Product / Process Change Notification (PCN)

PCN #: PCN_IndUCF_20210210

Affected Series: WE-UCF; 744290xxx

Carrier Tape design

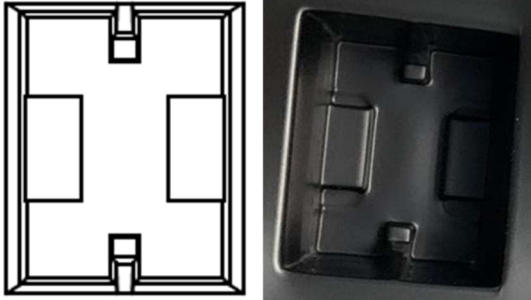
Würth Elektronik will update the carrier tape design and the marking technique in order to improve the reliability of the parts.
